**RE: 2018 NC Building Code, Section 508.2.2
Allowable Height Location for an Accessory Use**

RE: Formal Interpretation Request for The Park Multifamily Project, Chapel Hill, NC

Project: The Park at Chapel Hill, NC

A1.45

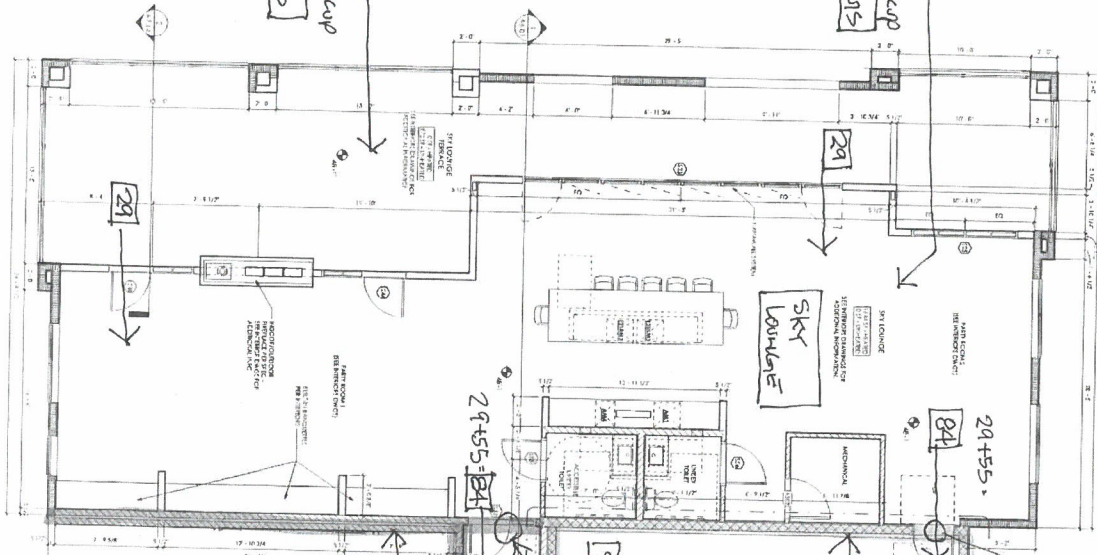
Exhibit 'A': Drawing A1.45,
 Enlarged Sky Lounge Floor Plan and Occupancy Numbers
 Drawing A3.07,
 Fifth Floor plan of building with fire areas and location of area in question
 Drawing A5.06,
 Partial Building Elevation
 Drawing A5.09
 Partial Building Elevation

- (3) Per Section 508.2.1, Accessory Occupancies shall be individually classified per Section 302.1 – The Sky Lounge is individually classified as A-2/A-3. Requirements must apply to each portion based on that occupancy classification – egress, etc. *that are not modified by Section 508.2* comply with Assembly Occupancy requirements.

TOTAL SKY LOUNGE AREA:
 = 2,556 SF (ACCESSORY TO R.2)
 $\frac{2,556 \text{ SF}}{53,078 \text{ SF}} = 4.8\%$

If a space meets all the other requirements of Section 508.2 for accessory occupancy spaces and the space is ancillary to the primary occupancy, then the accessory occupancy can be located on stories above those normally limited by Table 504.4 and Table 504.3. The proposed Sky Lounge in Exhibit "A", for example, can be located on the 5th floor of the proposed Type IIIA building because the NFPA 13 sprinklered Group R-2 (primary occupancy) is allowed by Table 504.4 to be 5 stories.

KEY PLAN
 5TH FLOOR - KEY
 A3.07

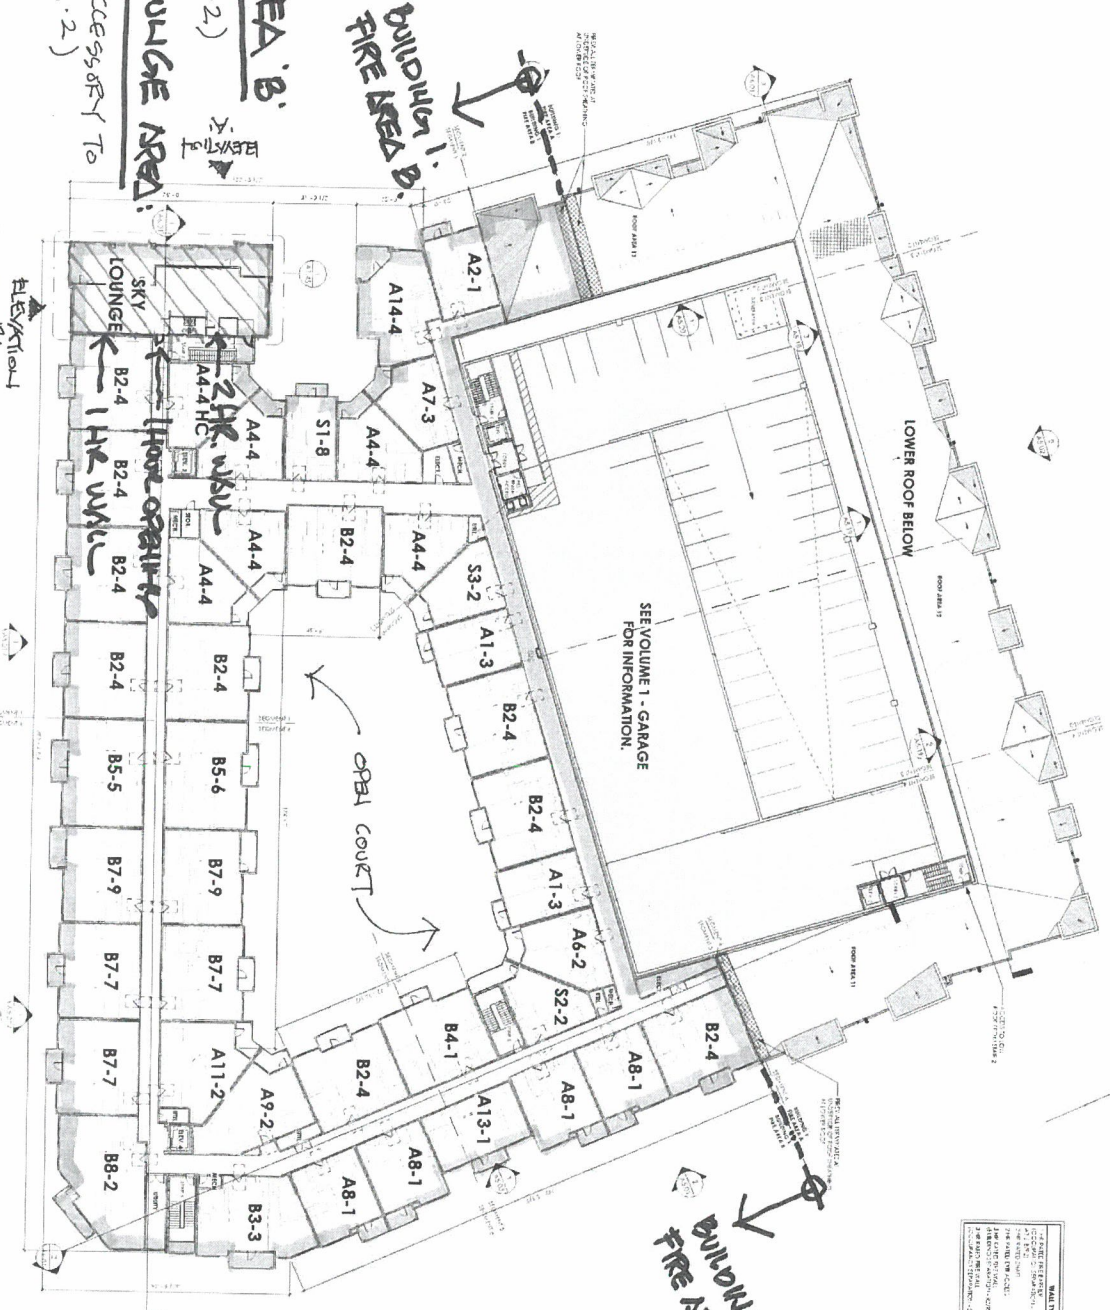
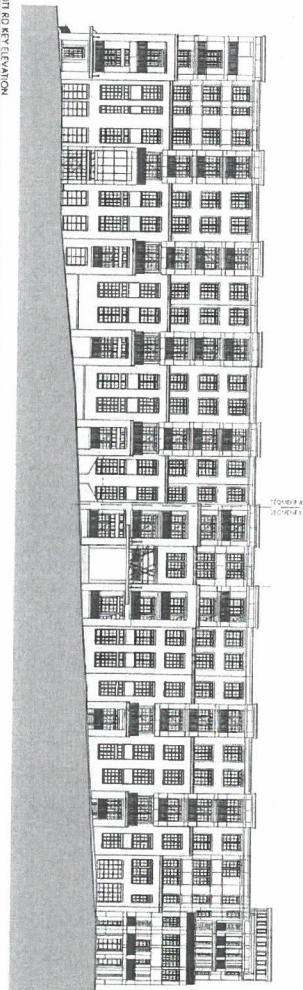
TOTAL FIRE AREA 'B'
 = 153,038 SF (R.2)

5th FLOOR ABOVE 3-HR. RADIUM (R.2 OCCUPANT / TYPE 3A CONSTRUCTION) (FOLLOWS SPRINKLER SYSTEM)

A5.06

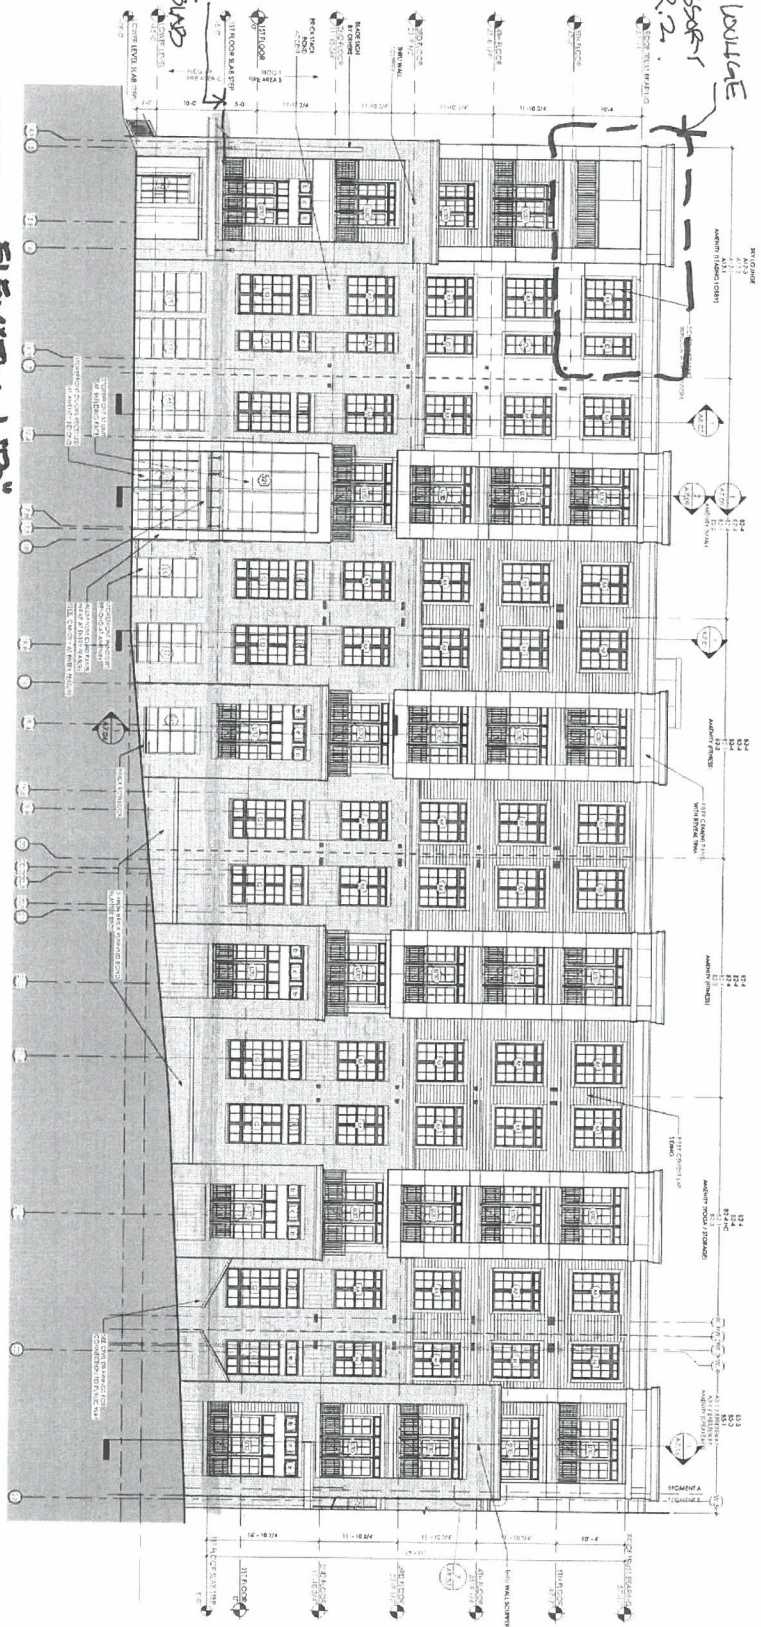
* SKI BOULDER ACCESSORY TO R.2.

3 HR CONCRETE FLOOR SLAB
